LVPS ELMB_MB v.6.5 modifications for version 6.5.2.

Summary: This document describes the component changes on LVPS ELMB_MB from produced version 6.5 into new version 6.5.2. All mentioned component names and values are referring to the scheme components designed by Ivan Hruska of ELMB_MB version 6.5.

Pic1: Top side photo of ELMB_MBv6.5. Remove 8x 10ohm resistors and short them or put zero ohm resistors.

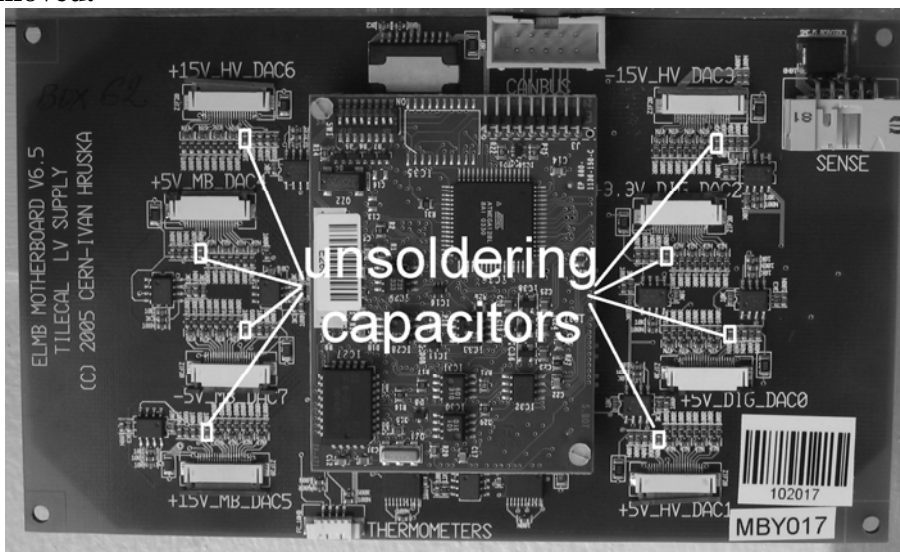
1. **Shortcutting ground resistors R 129 – 136. Put zero ohm resistors (to remove Vout dependency of the bricks on Start-up pulse).**

Pic3 and 4: Bottom side photos of ELMB_MBv6.5. Cutting traces and powering optocouplers from 5VDIG level.

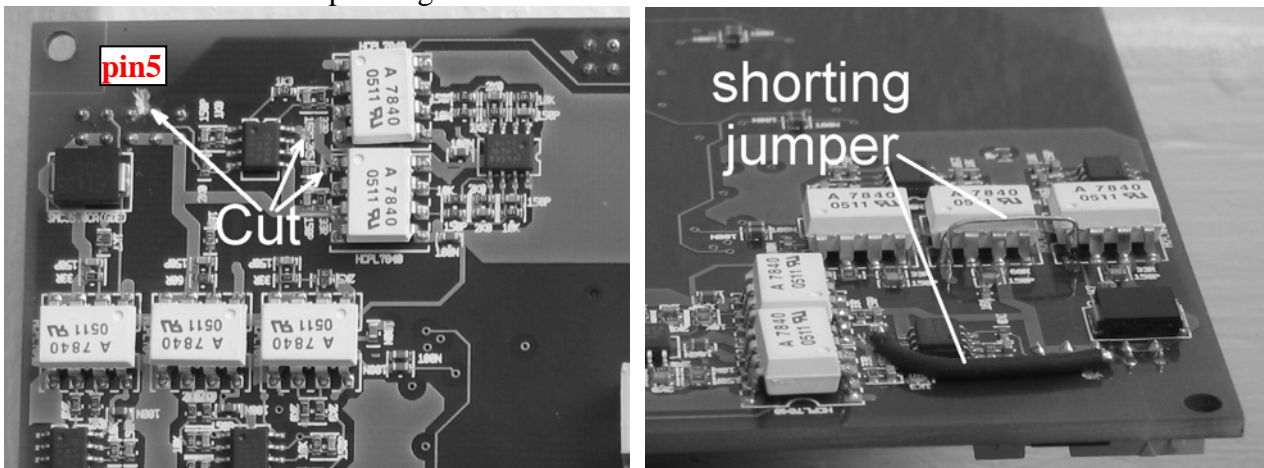
- (a) Cutting +5VMB pcb trace from pin 5 on connector J12 and resistor R27 (from MB bottom side, see Pic3).
- (b) Then R27 (part of +5VMB sense line divider) connect directly to pin 5 of J12 connector by a 30mm piece of wire (Pic4).
- (c) Then the Vdd of the U7, U10, U12 connect to the +5V DIG (pin 2, J12) in order to supply primary part of isolation amplifiers (HCP7840) to +5V DIG sense line without separating drawer resistors.

Pic.5: Part of the MB_ELMB V6.5 schematic documentation, from page no.7. Changes of sense line optocouplers powering do +5VDIG line, changing of resistor dividers for all sense lines. All changes are drawn in red color.

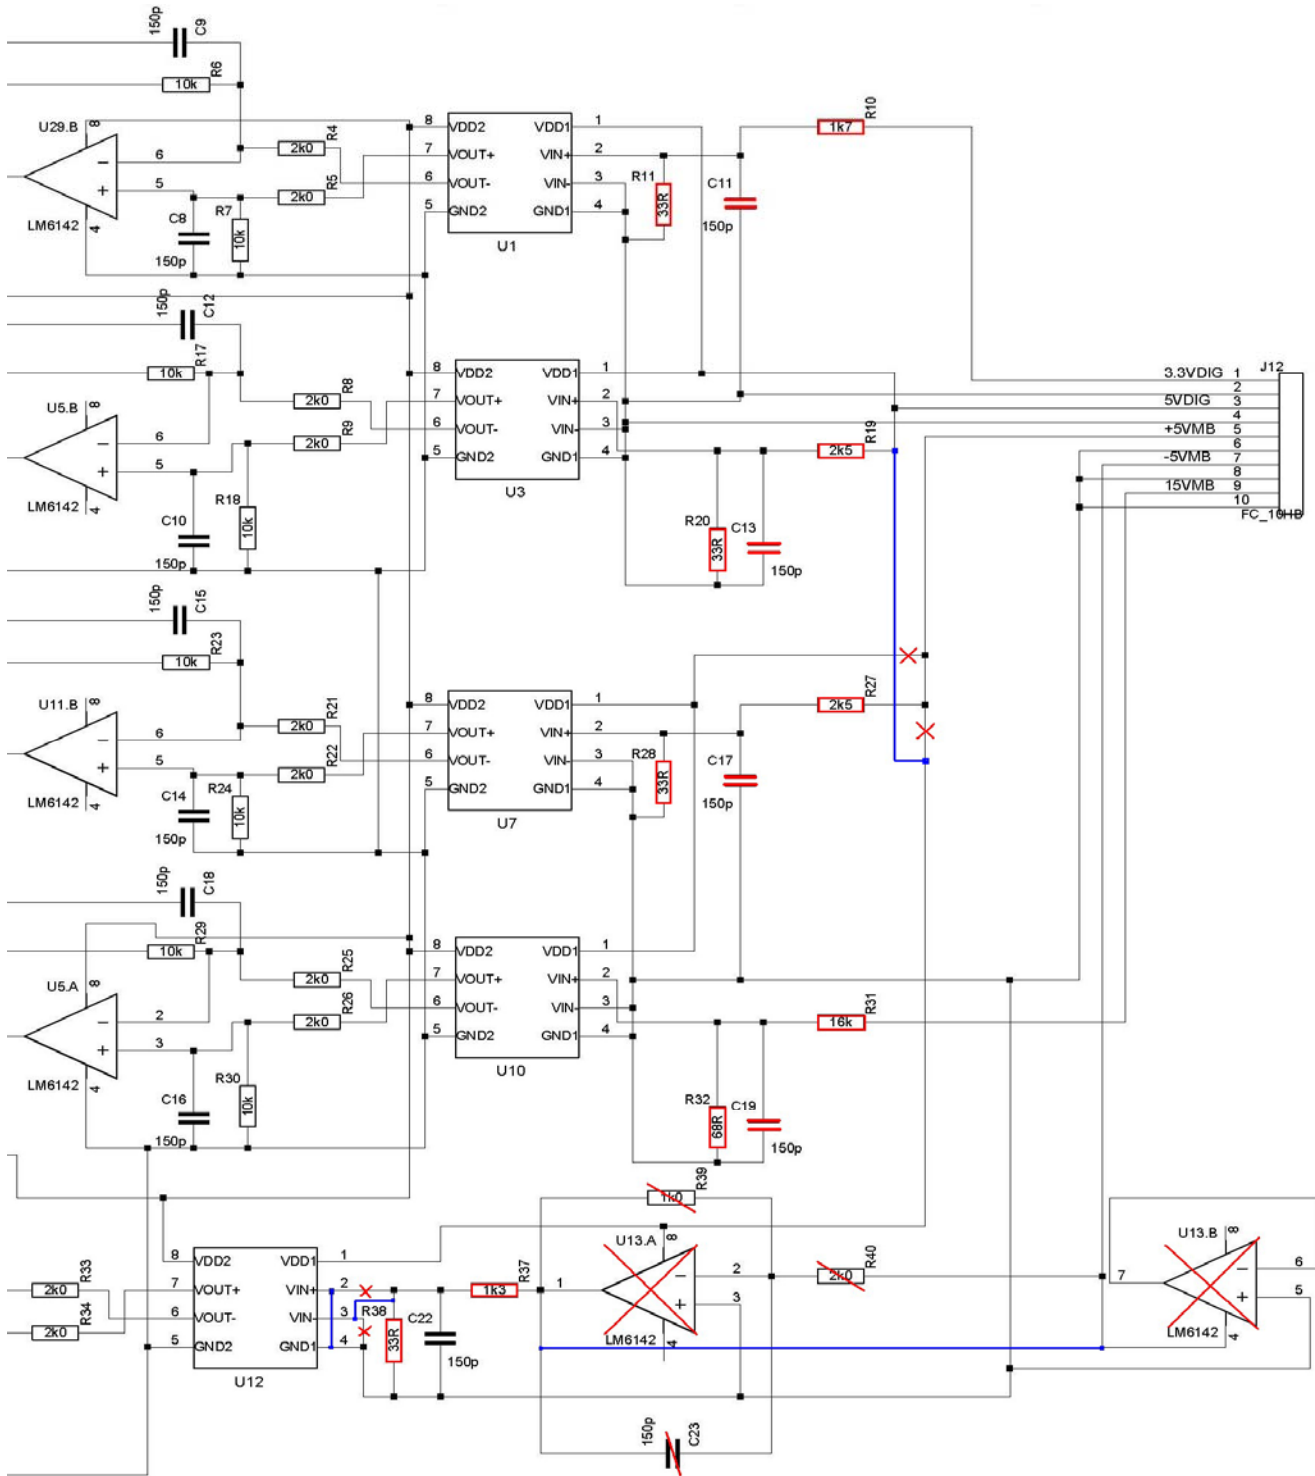
- (d) Unsolder opamp U13, resistor R39, R40, and capacitor C23 (no more needed to invert -5VMB sense lines, HCPL7840 can measure negative voltages).
- (e) Reconnect the resistor divider R37, R38 from positive to negative input (pin3) of U12 (HCPL7840).
- (f) Connect the R37 resistor directly to pin 7 of the connector J12 (-5VMB sense lines).
- (g) Nominal resistor values of ELMB_MB input sense line dividers were changed (see scheme on page 3).
 - R11, R20, R28, R32, R38 = 200 ohm
 - R10 = 10k,
 - R19 = 16k,
 - R27 = 15k,
 - R31 = 47k,
 - R37 = 15k

- (h) Solder ceramic capacitor 10uF to pins 2-3 of U1, U3, U7, U10, U12, to increase the nominal filtering capacitor values of C11, C13, C17, C19, C22.
- (i) Solder the Tantalum stabilization capacitor 68uF instead of Transil device D5.
